UNITED STATES PATENT AND TRADEMARK OFFICE

APPLICATION NO.	FILING DATE	FIRST NAMED INVENTOR	ATTORNEY DOCKET NO.	CONFIRMATION NO.
10/073,668	02/08/2002	Heinrich Englert	P6608.0US	4591
30008	7590	11/16/2005	EXAMINER	
GUDRUN E. HUCKETT DRAUDT LONSSTR. 53 WUPPERTAL, 42289 GERMANY			GOODMAN, CHARLES	
			ART UNIT	PAPER NUMBER
			3724

Office Action Summary

DETAILED ACTION

Fig. 7

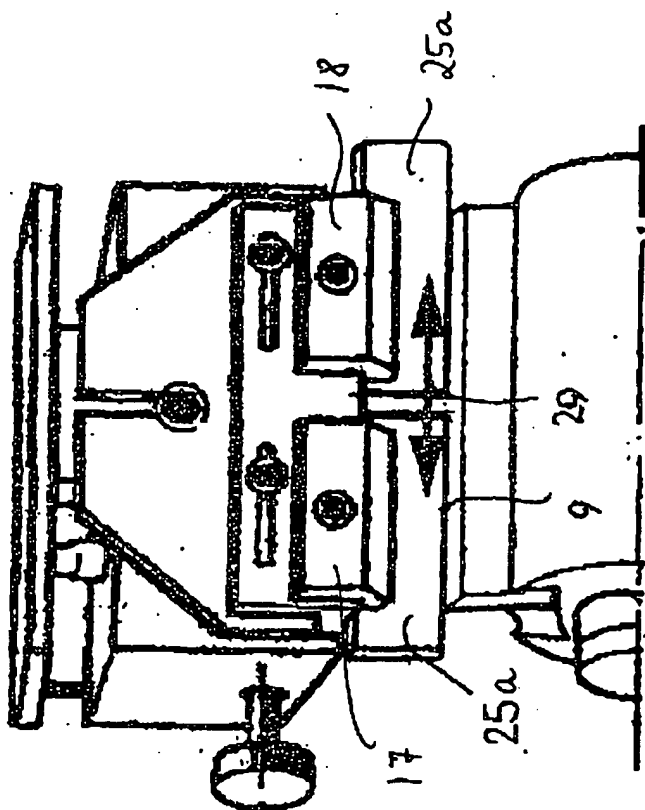
1. The Amendment filed on 8/24/2005 has been entered.
2. The drawings were received on 8/24/05. These drawings are not accepted because they introduce new matter. Contrary to Applicant's assertions, the depiction shown in the resubmitted Fig. 7 is not the only manner that complies with the specification description. For example, the stone members may be profiled and the minimal spacing does not have to be to the extent shown in Fig. 7, i.e. it could be larger or smaller.
